CITY OF LAVON Agenda Brief

Discussion and action regarding the site plan and landscape plan of the Lavon Retail Project at 616 Cedar Street on Lot 4, Block F of the Replat of Lake Breeze Estates Block A, Lot 32C Addition on 1.22 acres out of the Samuel M. Rainer Survey, Abstract No. 740, northwest of the intersection of S.H. 78 and Cedar Street, City of Lavon, Collin County, Texas (CCAD Property ID 2918093).

Re: Lake Breeze, Lot 4
Revised Site Plan Review
LJA Job No. NTP-3880
MyGov Submittal: September 17, 2026

Re: Lake Breeze South Commercial – Lot 4 - 1 Lot, 1.227 Acres
Lavon Retail
Site Plan Review

SHEET: 4
C-1.0

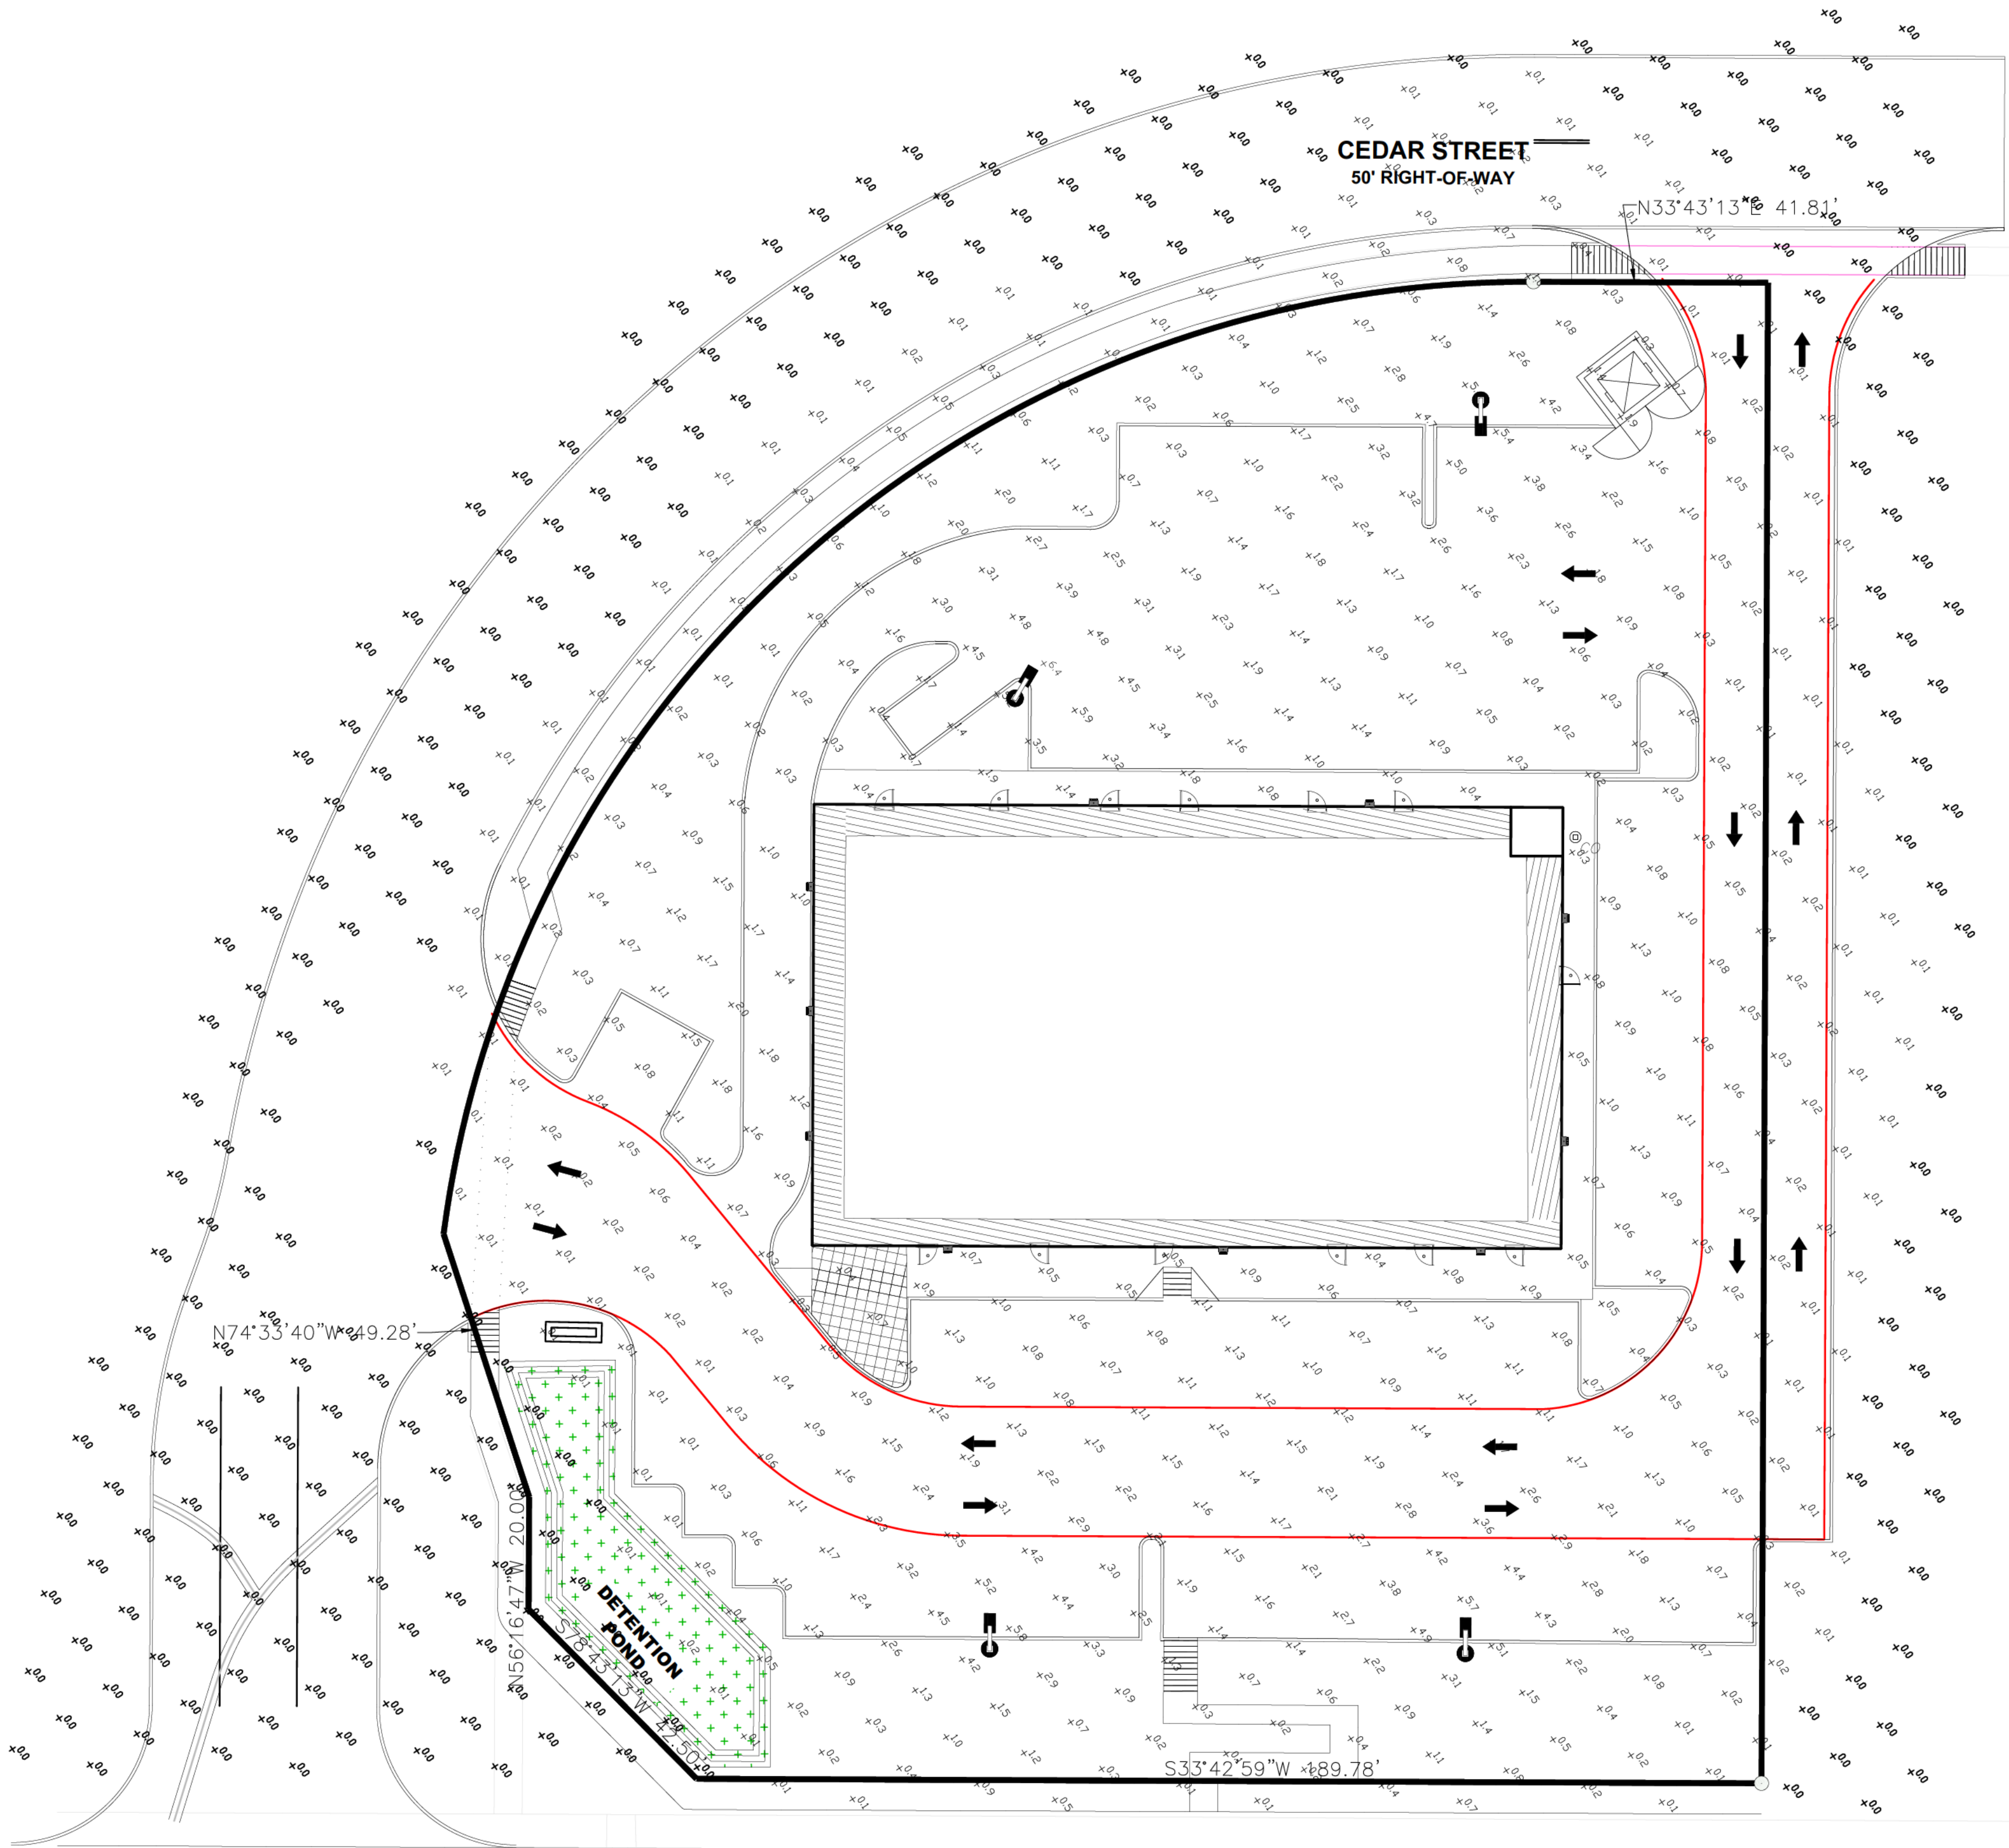
3. **REPEAT COMMENT:** Revise the Site Plan to provide the filing information for the onsite portion of the 24' Fire Lane, Drainage, and Mutual Access.

The filing information does not appear to be included. Revise the Site Plan to include the filing information for the onsite portion of the 24' Fire Lane, Drainage, and Mutual Access Easement by separate instrument.

Common Easment will file upon approval of Site Plan

1 FRONT ELEVATION
1/8" = 1'-0"

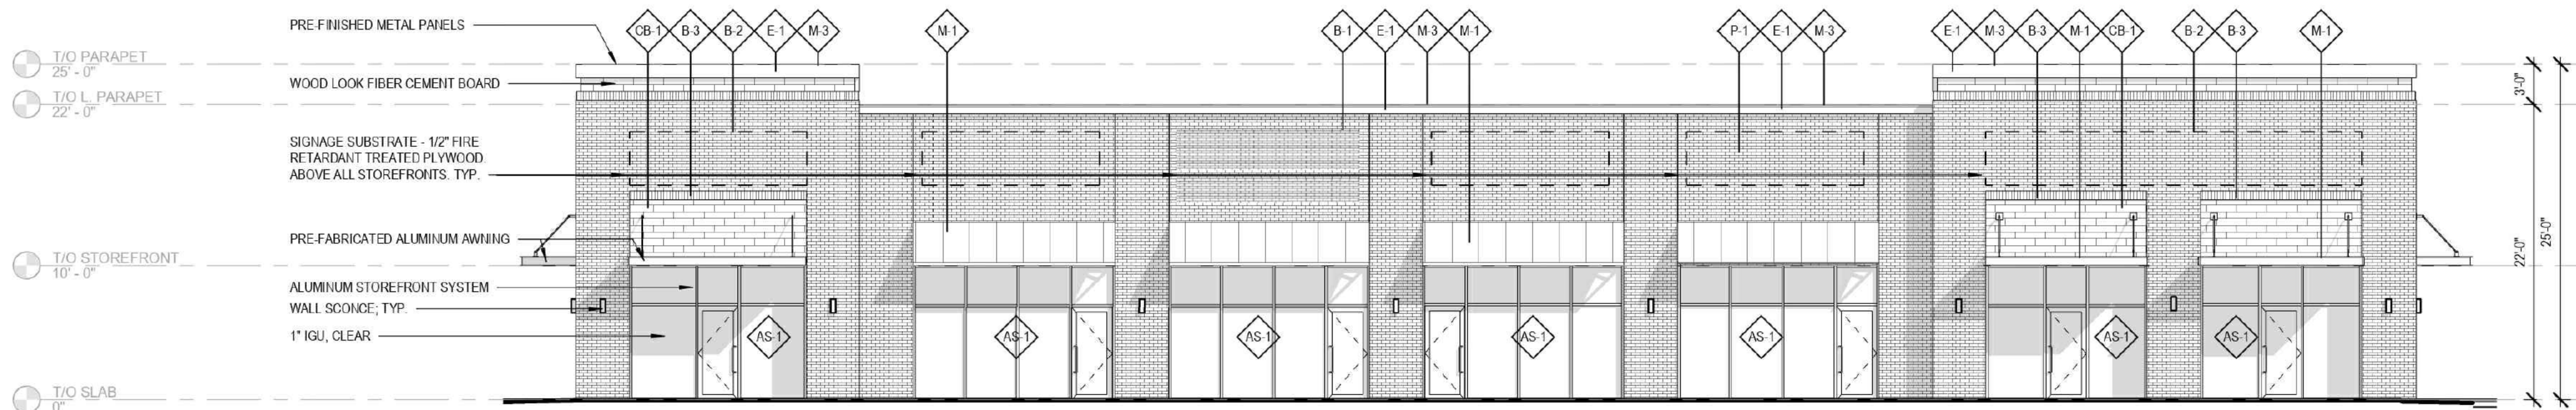
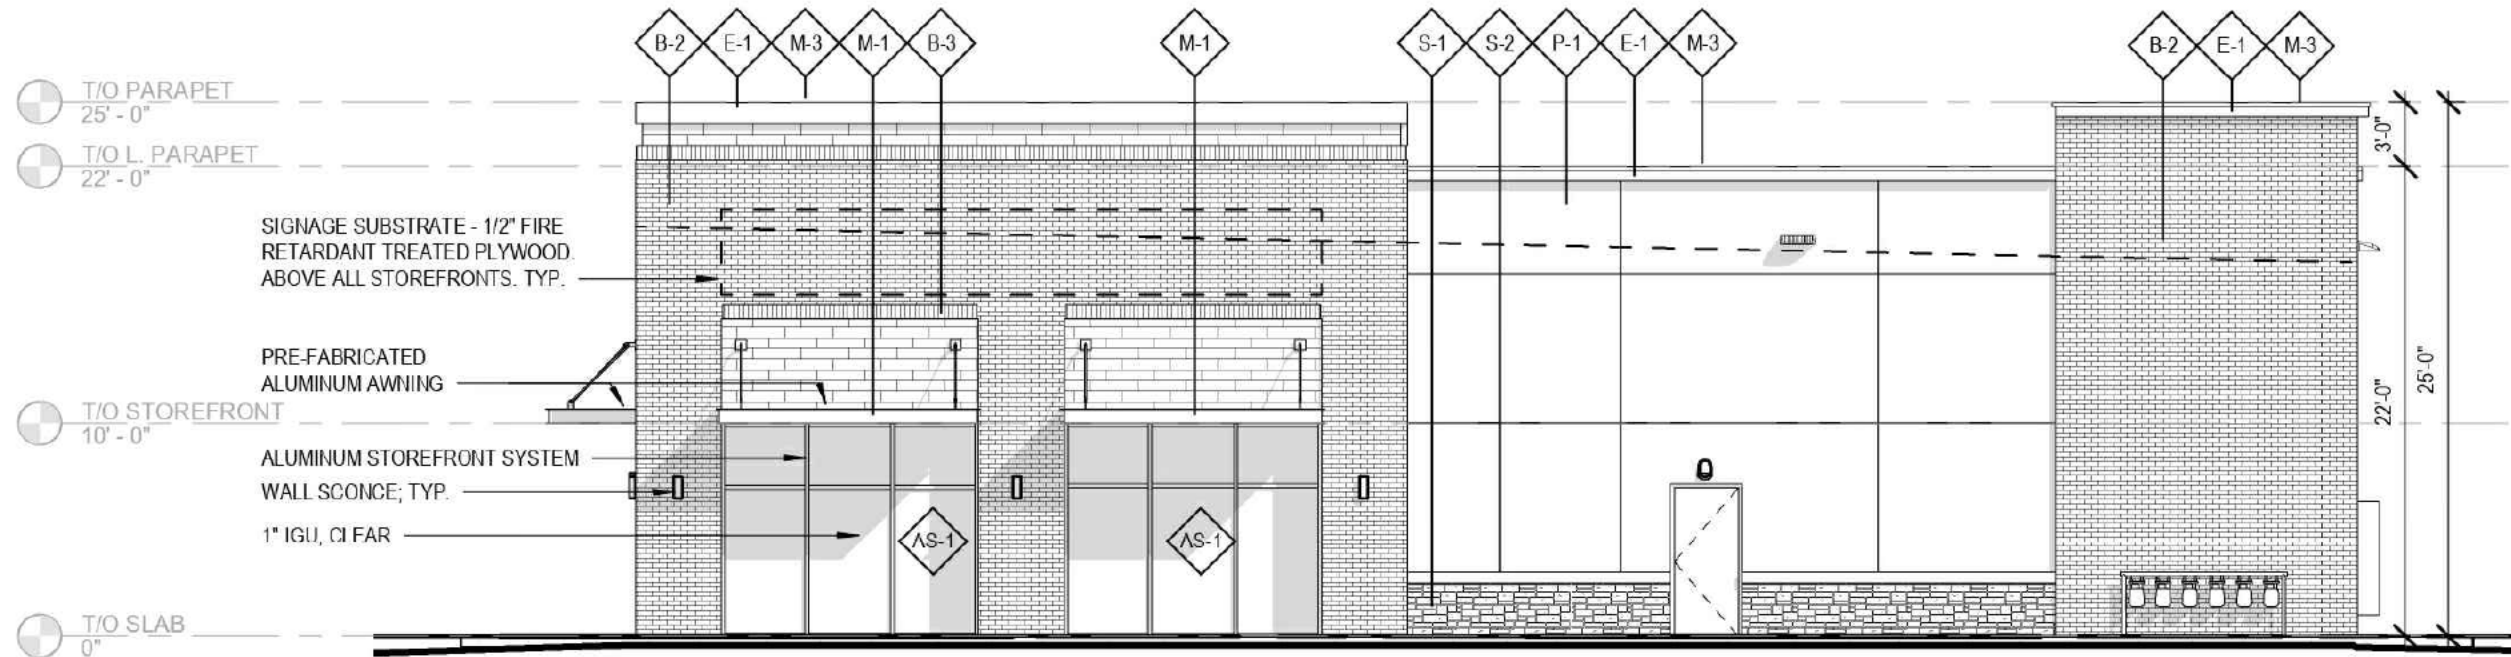
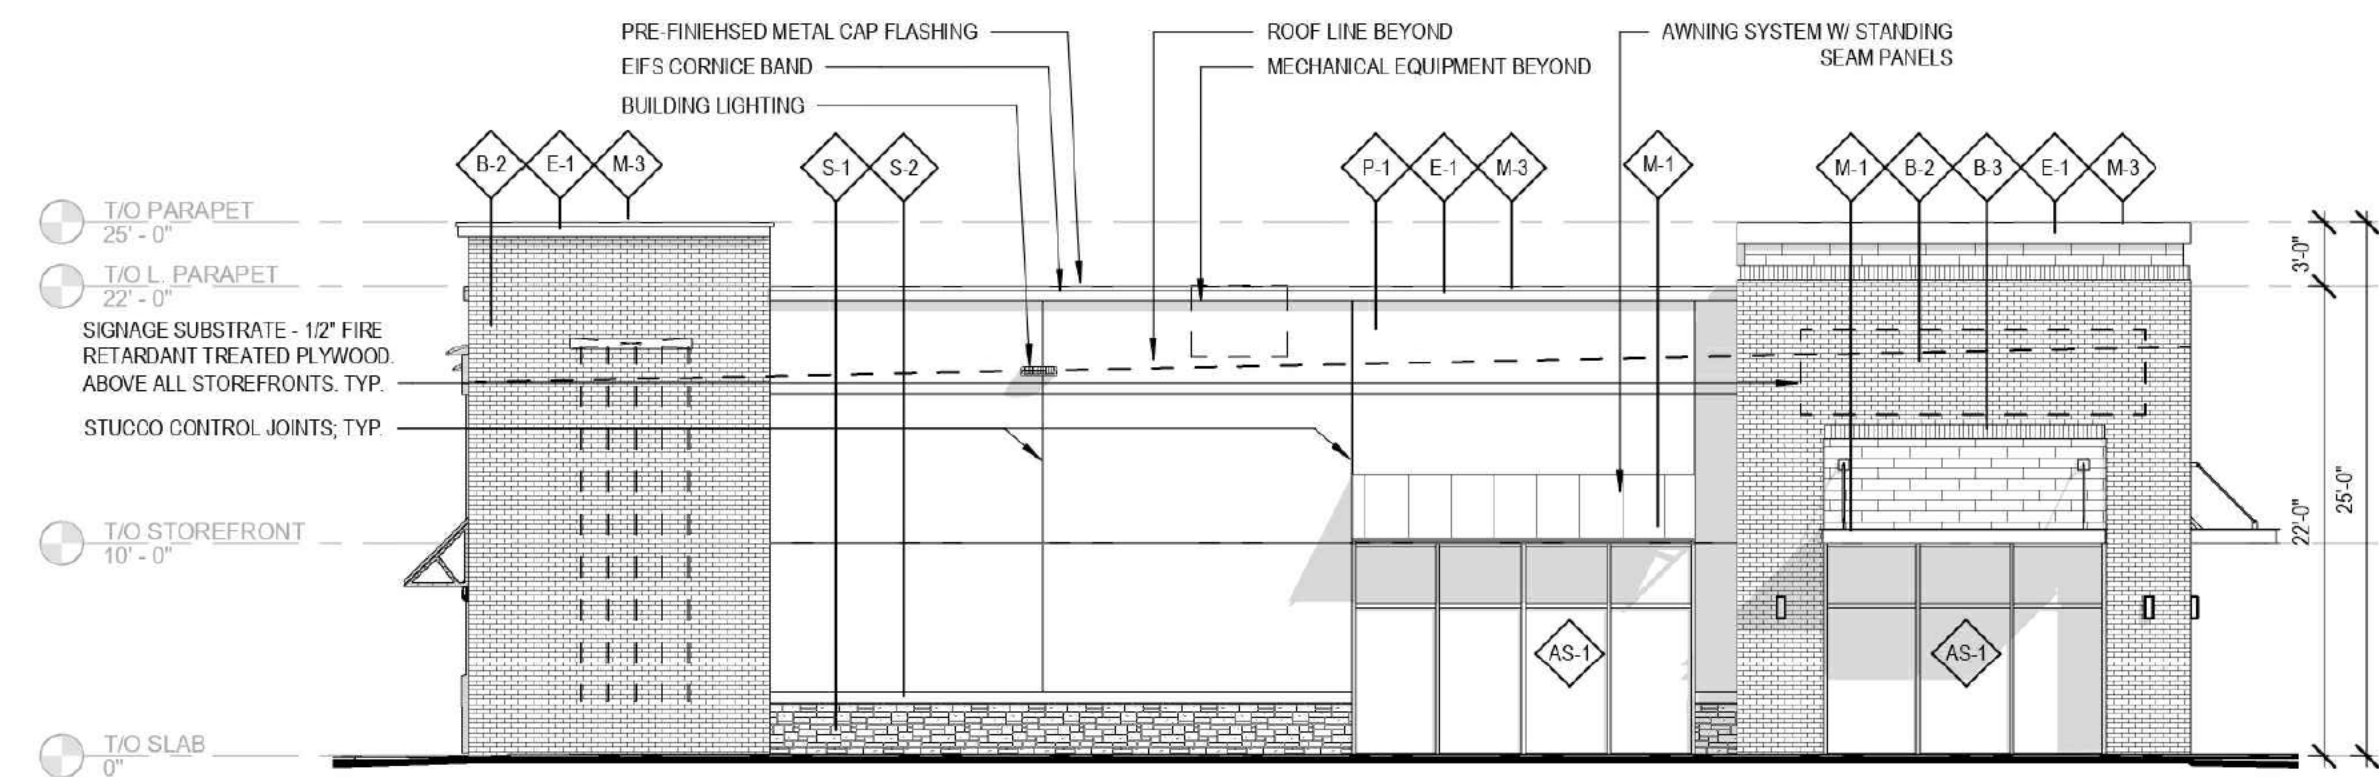
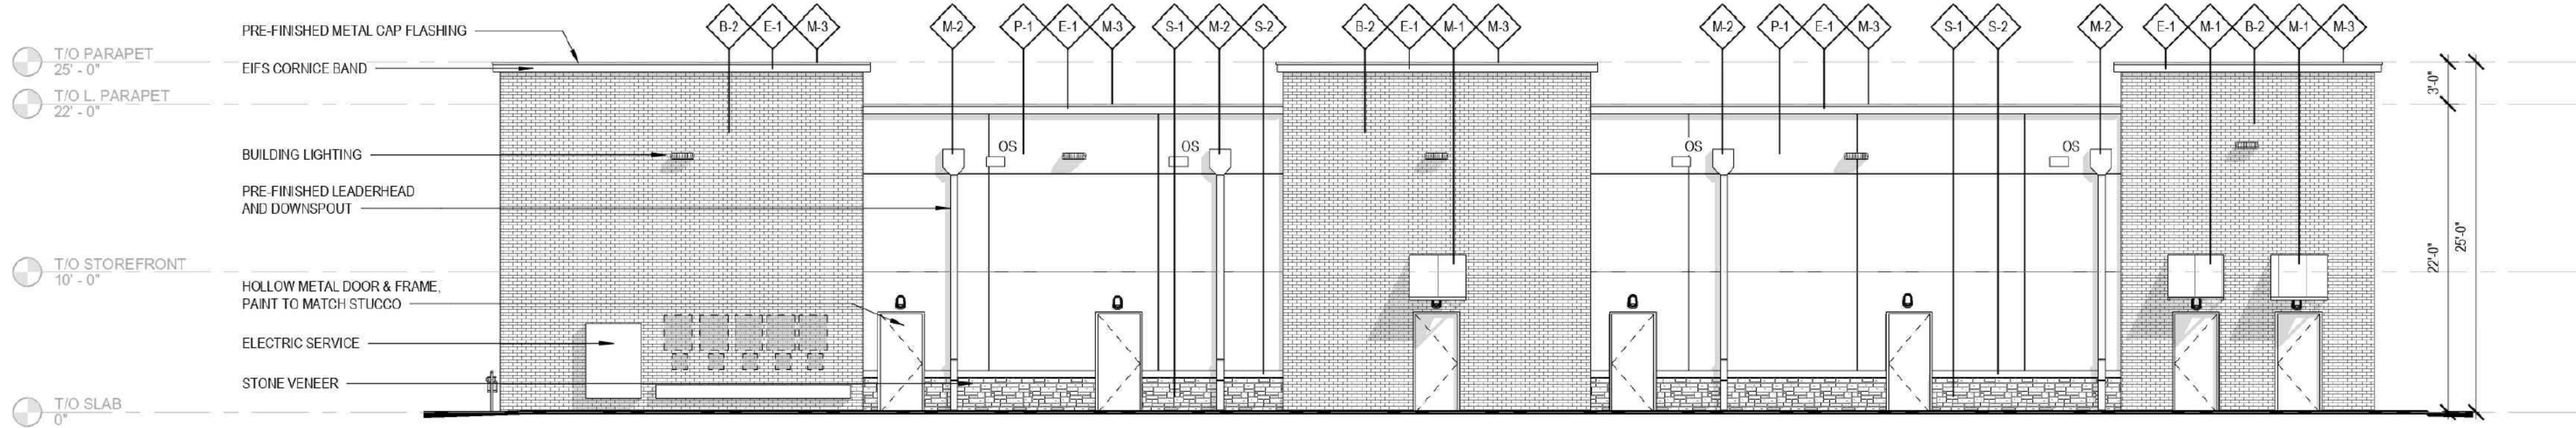
The Photometric Plan has been revised to match the revised Site Plan. However, the Building Elevations appear to show six tenant spaces while the Site Plan shows five tenant spaces. Please confirm the number of tenants and revise the associated plans accordingly.

The Photometric Plan has been revised to match the revised Site Plan. However, the Building Elevations appear to show six tenant spaces while the Site Plan shows five tenant spaces. Please confirm the number of tenants and revise the associated plans according. Addressed and updated on plan. removed signage on unit "3" as it is the same unit as
